MADISON HOLLOW SUBDIVISION  
(MINOR PLAT)

## SUMMARY

**Applicant's Request:** The applicant proposes to replat a vacant commercial property for the future development of senior-oriented multi-family apartments and two (2) commercial outparcels. The property is located in the Kirkman North neighborhood.

PROPOSED  
PLAT

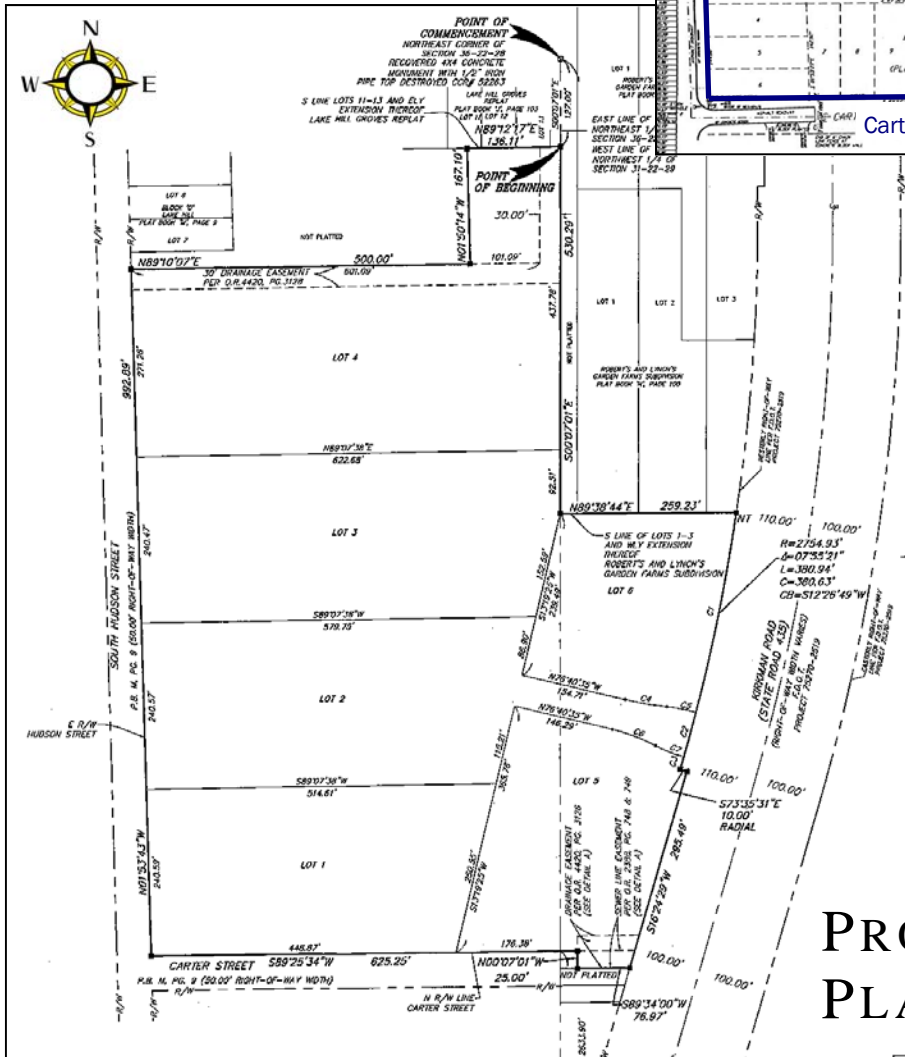
1. Show a roadway / cross access to Lots 1-4. Also show emergency access to Carter St.
2. Ingress and Egress easements shall be granted from Lots 1 and 2 to all other lots created by this plat. These easements shall be shown on this plat.
3. Provide additional R-O-W so that, in the future, Carter St. can connect to S. Kirkman Rd. The R-O-W provided shall match the existing R-O-W width on Carter St.

1. If the plat dedicates nothing to the public, it must so state in the dedication.
2. A joinder & consent is required for the mortgage recorded in 6038/2494.

Addressing - Please change "South Hudson Street" to "S Hudson Street" and "Kirkman Road" to "S Kirkman Road".
